RECEIPT DATE: 2/1/23 **ONSITE SEWAGE DISPOSAL SYSTEM** P 572769
 APPROVAL DATE: 3/23/2023 **SPERMIT: UPGRADE** A _____
 PROPERTY ADDRESS: 1801 Long Corner Road
 SUBDIVISION: Stone Property LOT: 4 TAX ID: _____
 CONTRACTOR: Fogles Septic Clean Inc. EMAIL: kim@foglesinc.com
 CONTRACTOR ADDRESS: 580 Obrecht Road, Sykesville, MD 217845 PHONE: 410-795-5670
 PROPERTY OWNER: Josef Behling EMAIL: _____
 OWNER ADDRESS: 1801 Long Corner Road, Mount Airy, MD 21771 PHONE: _____
 SEPTIC TANK SIZE (GALLONS): 2000 TANK MANUFACTURER: Mayer Bros
 PUMP MODEL: n/a PUMP SIZE n/a PUMP TANK CAPACITY: n/a

SEWAGE DISPOSAL SYSTEM

ONSITE SEWAGE DISPOSAL SYSTEM PLAN
BEHLING PROPERTY
1801 LONG CORNER ROAD, MOUNT AIRY, MD. 21771
LOT 4
PLATTED AS "STONE PROPERTY LOTS 3 AND 4"

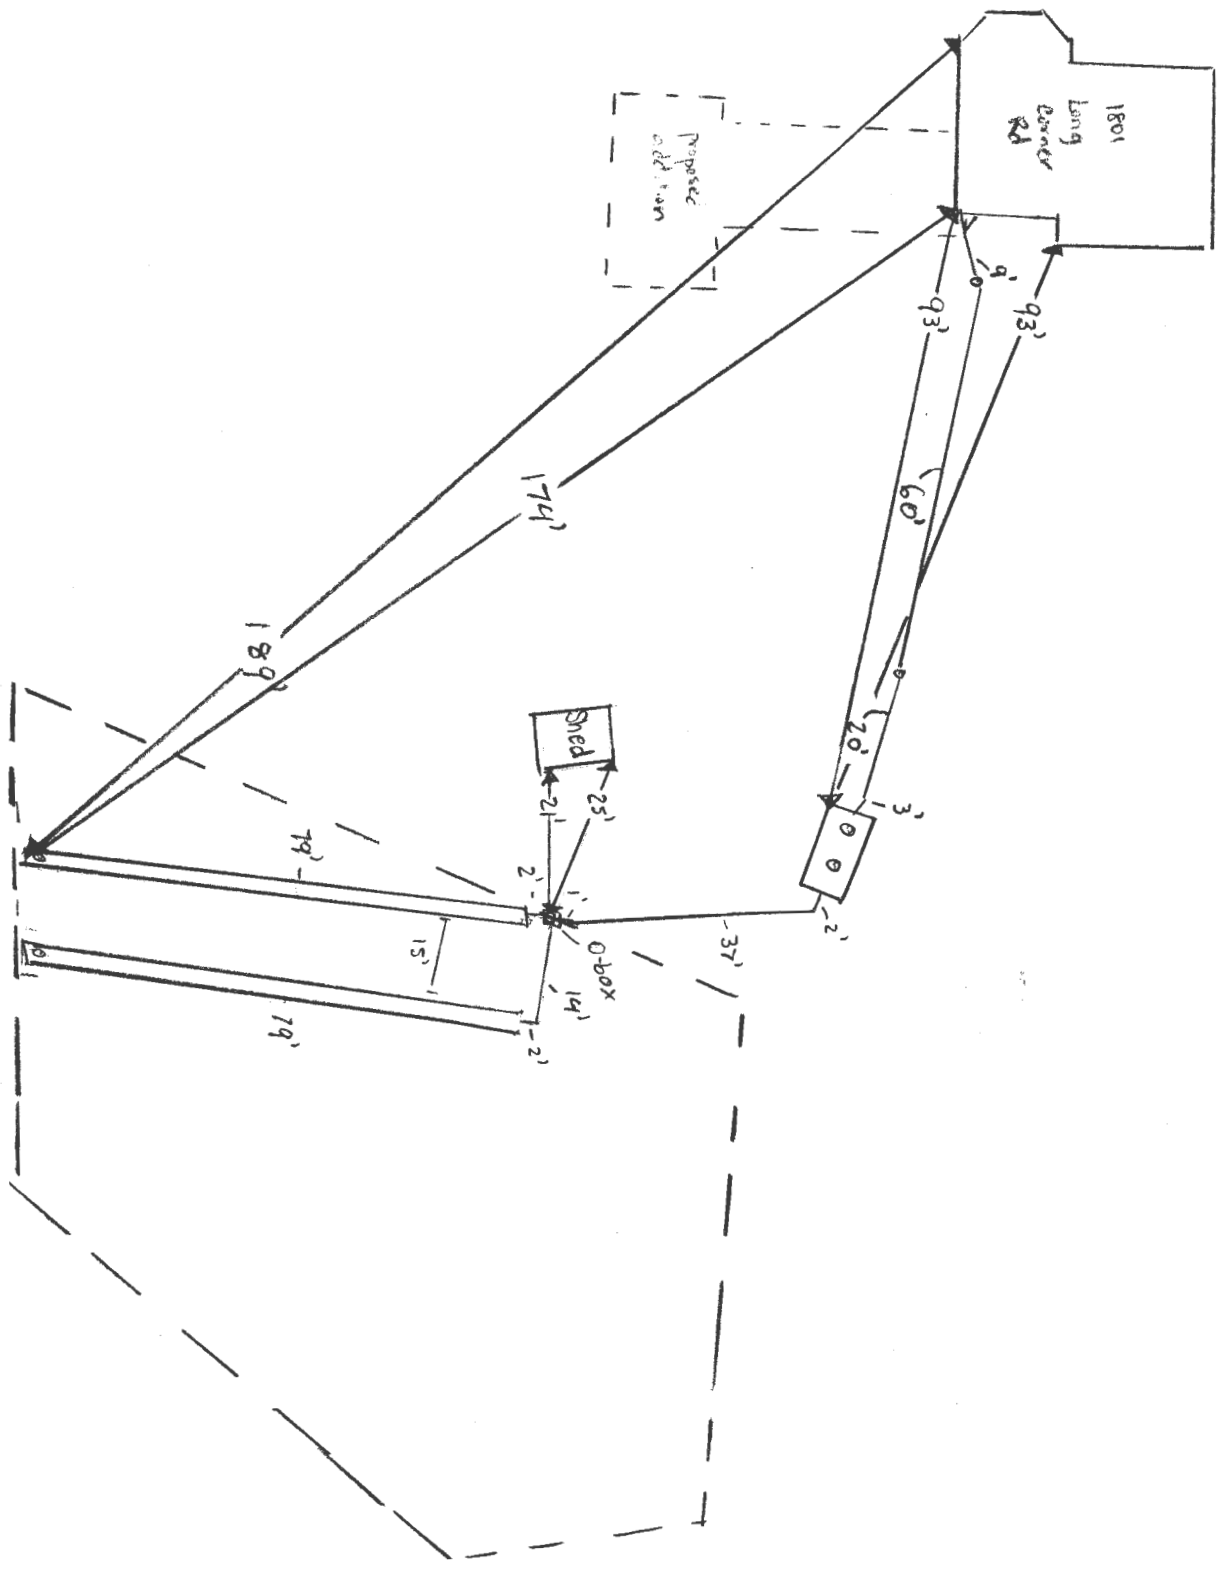
3/13/23 - Contractor & home owner onsite for pre-con, tank & d box staked, laid out 2 trenches @ 80' each on contour. Contractor wants to change location of d box to move it out of the area where the cesspool was located and bring it closer to the trenches. ok to continue (20)

INSTALLATION: 3/20/23 - site inspection, contractor onsite excavating for the septic tank and hitting nothing but rock, they will need to use the jack hammer on the backhoe first then the 3' bucket. (20)

3/21/23 - Contractor used a jackhammer on the backhoe to get through the rock in the septic tank hole, tank set but nothing connected, one backhoe digging the sewer line and mini skid loader working on stone for the bottom trench, stone looks ok, no fabric installed yet, could not triangulate st's trench, too much in the way, will need to get distances on 3/22/23, ok to continue. (20)

3/23/2023 - 6" sleeve from house. Lots of rock found in upper 4' of 1, see attached pictures. D box leveled, measured trenches, both @ 79". Saw 6" front baffles & 4" back baffles. Saw slots. Saw beginning of 1, fabric & stone & obs. port. Saw entire 1, 2, fabric & stone & obs port. (50)

SITE INSPECTION SHEET

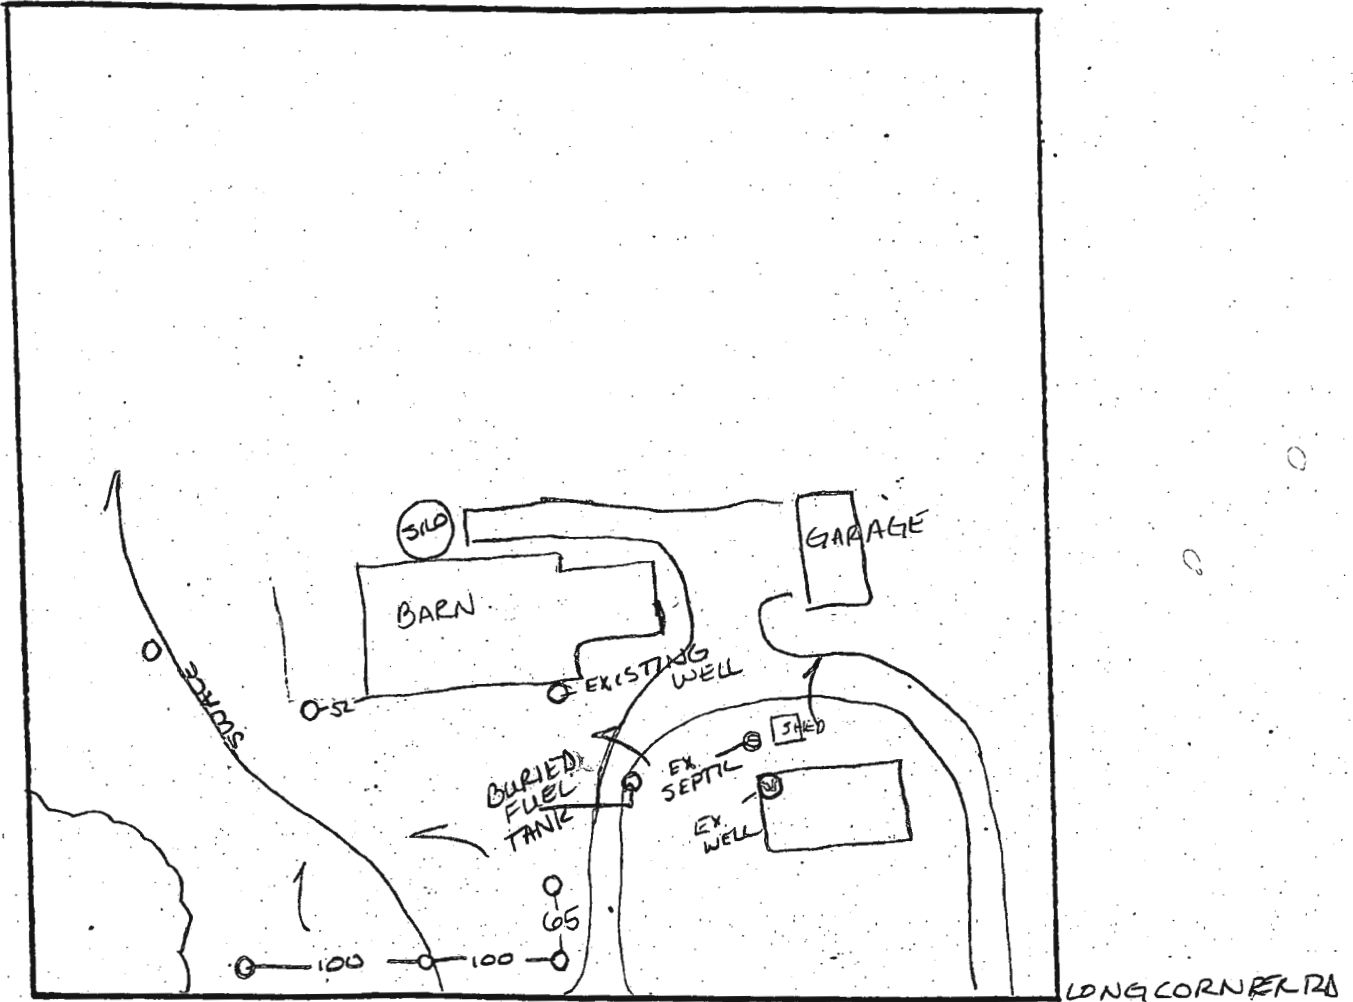
PROPOSAL: 4/26/96 Inspection to verify actual locations of test holes to determine if re-perc is needed for subdivision Au

COMMENTS: 5/3/96 APPEARS THAT ADJUSTMENT OF EXISTING SEPTIC ESMT TOWARD'S LEFT PROPERTY LINE IS EXTREMELY LIMITED DUE TO SWALE LOCATION. ALSO, EXISTING WELLS ARE IN QUESTION DUE TO PROXIMITY EXISTING SEPTIC AND BU

SEPTIC SYSTEM AND A BURIED FUEL TANK

REGULATIONS REQUIRE A MINIMUM OF 100

FOOT SEPARATION. IN LIGHT OF THESE FINDINGS,

IT IS SUGGESTED THAT THESE WELLS BE TESTED

TO CONFIRM THE EXISTENCE OF A SAFE DRINKING

WATER SUPPLY.

PROPERTY OF THE STONES
18-1 LORIC CORNER LOT
BY HOWARD COUNTY, MD.

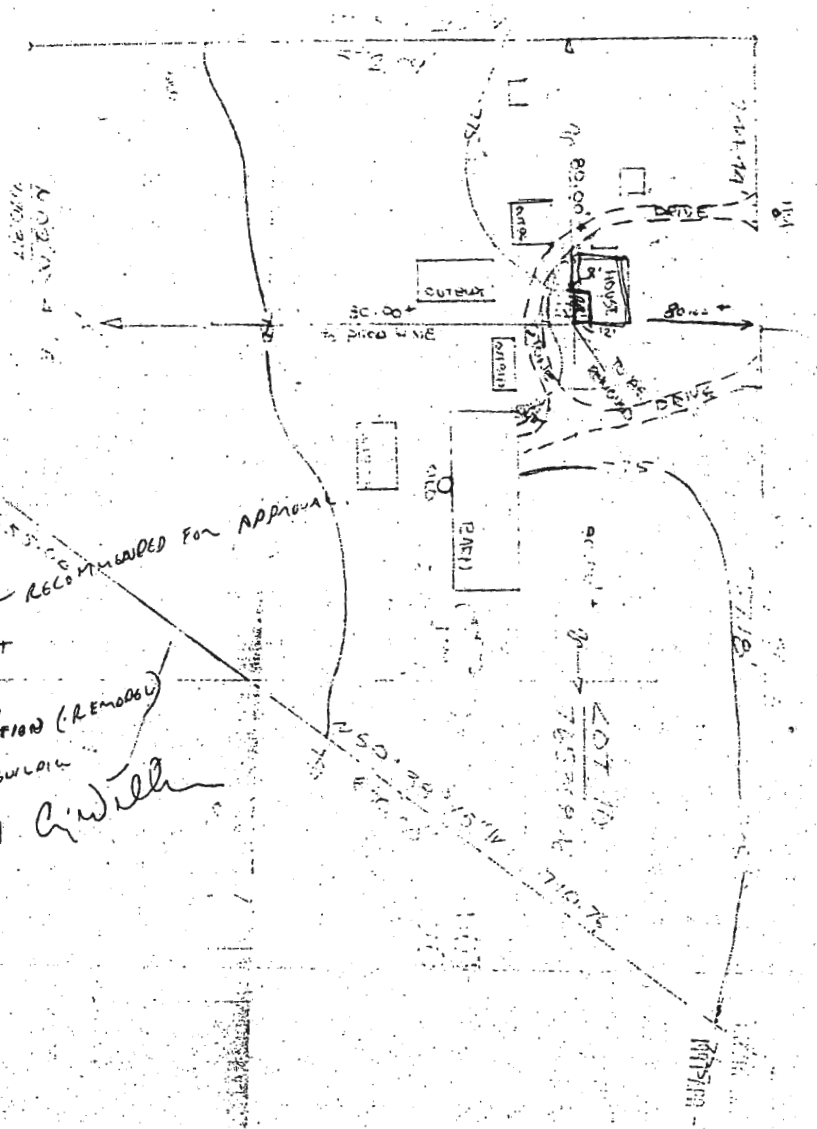
We propose to put up a new block wall (on well pit)
with a door so that EASY ACCESS is available
to the well in the basement. When finished (concrete to)
the wall will be approximately 2' above our
finished basement floor.

Proposal appears to be a slight improvement
over existing condition (at least no worse),
at least to provide protection and
accessibility -
Recommendation accepted
OK - [Signature] Building Dept
4/3/97

600104721 - PROPOSED ADDITION - RECOMMENDED FOR APPROVAL
 APPLICANT HAS DEMONSTRATED THAT
 EXISTING WELLS WILL BE
 ADEQUATELY PROTECTED
 BY NEW CONSTRUCTION (REMOVAL)
 OF EXISTING BUILDING
 4/3/97 C. Will
